LOCATED IN THE SW 1/4 OF SECTION 03, TOWNSHIP 19 NORTH,
RANGE 4 EAST OF THE WILLAMETTE MERIDIAN, CITY OF PUYALLUP,
PIERCE COUNTY, WASHINGTON

PRUSR20231267

D1

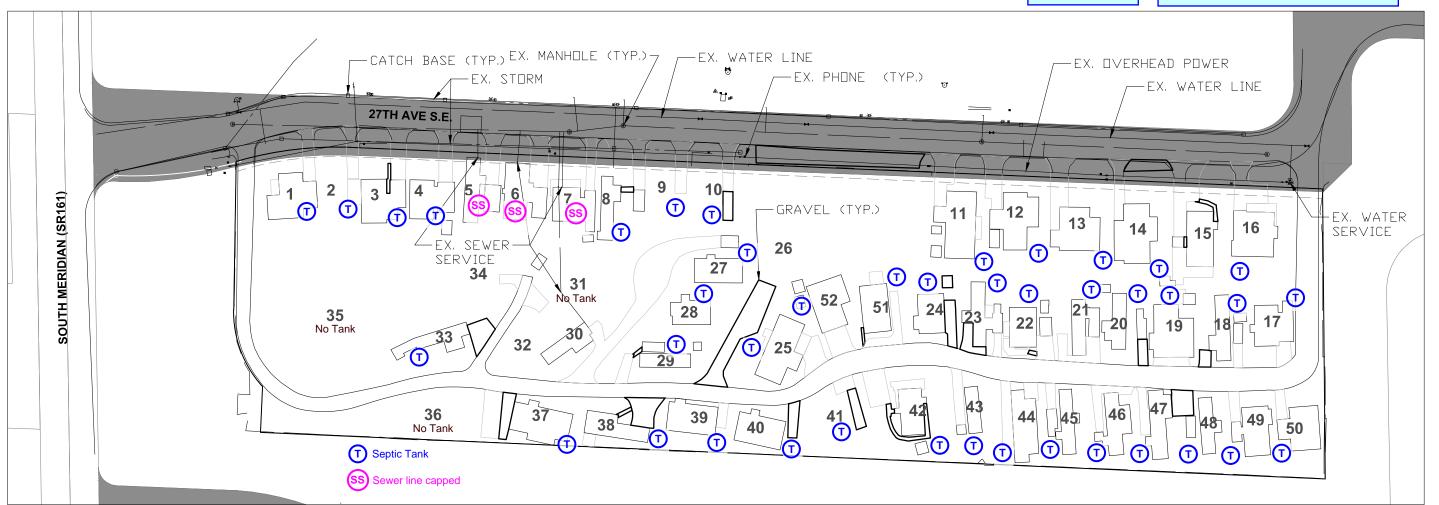
Refer to the City standard details 02.03.02 & 05.02.01 for typical erosion and sedimentation control methods.

The applicant shall coordinate water service removal with Fruitland Mutual Water Company.

Septic Notes: #05, 06, 07 tied to the sewer #30 shared sewer with #07 Total of 42 septic tanks

The applicant is responsible to demolish the existing septic systems that serve units 1-4, 9-11, 13-20, 22, 24-29, 31-32, 34-37, 39-41, 46, 49-50 per Tacoma Pierce County Health Department standards. The City Inspector shall verify that there are no septic tanks for units 31 and 35 as labeled on the site plan. Septic decommissioning certificates are required to be filed with Pierce County and copies submitted to the City of Puyallup.

The septic decommissioning for units 21, 44, 45, & 47 is permitted under PRDE20230753. The septic decommissioning for units 8, 12, 23, 33, 38, 42, 43, & 48 is permitted under PRDE20231242.

The applicant shall expose, cut, and cap the inactive sanitary sewer stubs for units 1, 2, 3, and 4 under the supervision of a City Inspector prior to demolition or removal of the mobile home. Furthermore, the applicant shall cut and cap the sanitary sewer lateral for units 5, 6, and 7 under the supervision of a City Inspector prior to any demolition or removal of the mobile home. The sanitary sewer line for unit 30, permitted under PRDE20231242, must be cut and capped before disconnecting units 5, 6, or 7.

The existing sewer lateral shall not be reused. The applicant shall request an inspection through the CityView portal. Utility inspections are required prior to backfilling.
